FERGANA VALLEY AUTOMATION PROJECT

October 11 to 26 Mission

REPORT FROM INTERNATIONAL EXPERTS

ANNEX 1 AHUNBABAËV TEST

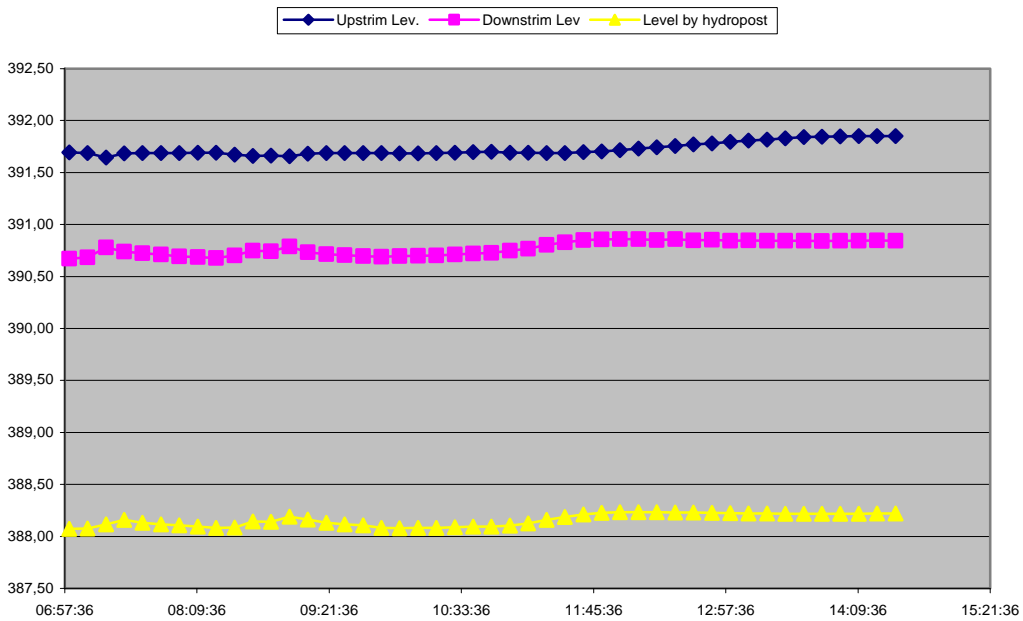
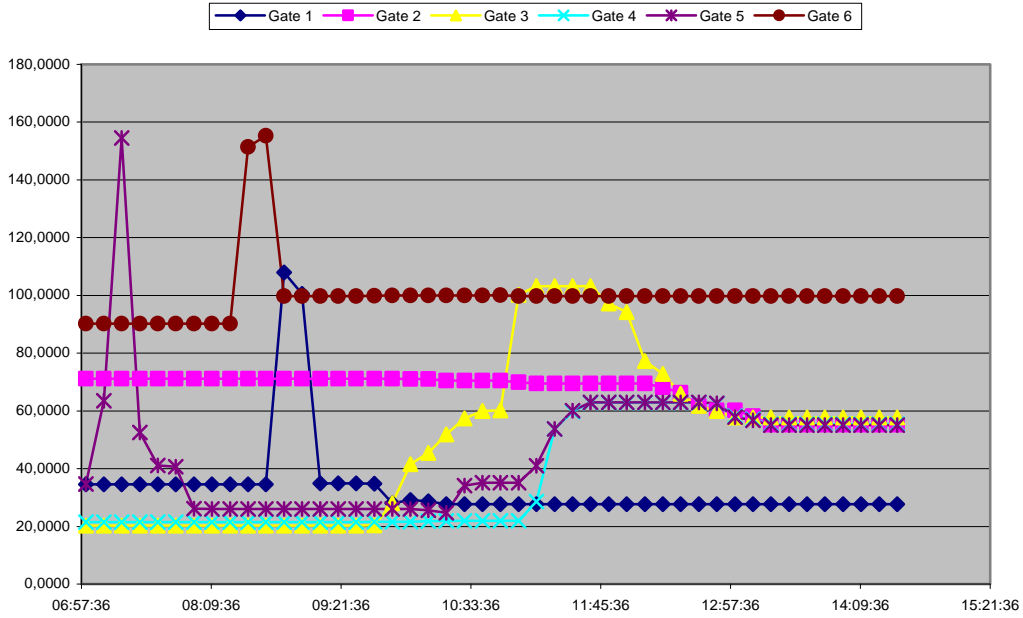
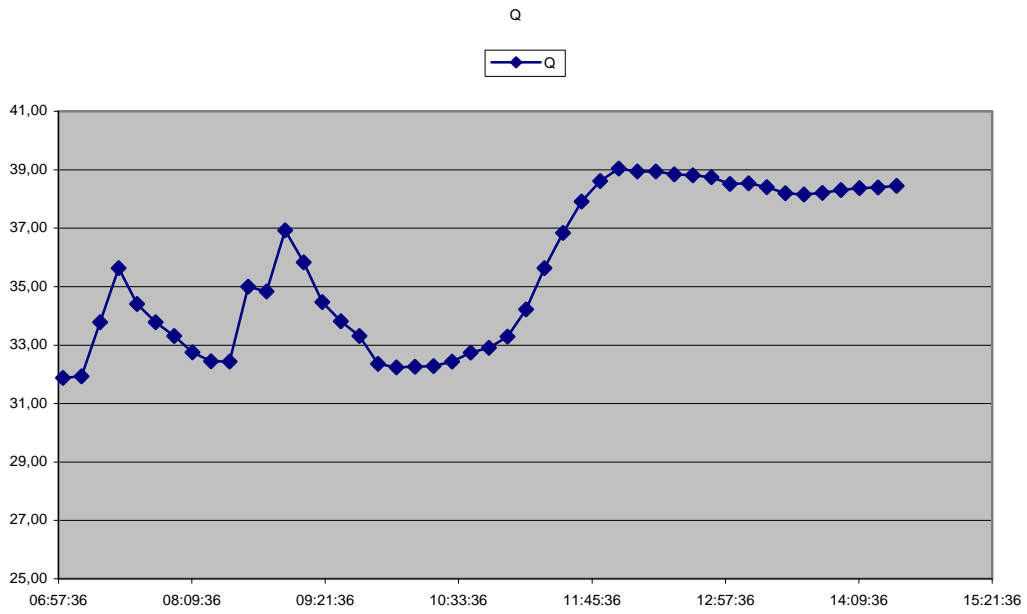
At 11 00 flow from Naryn River was 33 m³/s, water level upstream was 391.69. Gates were put in the automatic mode with a new set point of 38 m³/s. 10 minutes latter, 2 gates out of 6 were faulty but the adjustment continued without problem with the 4 other gates.

The adjusted value of 38 was reached at 11 50 and remained stable until the end of the test 14 30 although the level rose by 20 cm.

The reading have been taken from the computer and put on the graphs in annex 1: opening of gates, Water level and discharge. On these graphs it can be seen that local staff has operated the gates manually at 7 00 and 9 00 giving picks of discharge.

Concerning level, it must be pointed out that values in the different points are not consistent:

At the end of the test they were: Upstream 391.85, Downstream 390.80, Hydro post 388.20 and at the Outfall 394.65. Level measurement devices have to be adjusted and tuned.

Conclusion:

This test is satisfactory although 2 gates remained permanently faulty.

Level sensors must be tuned and adjusted.
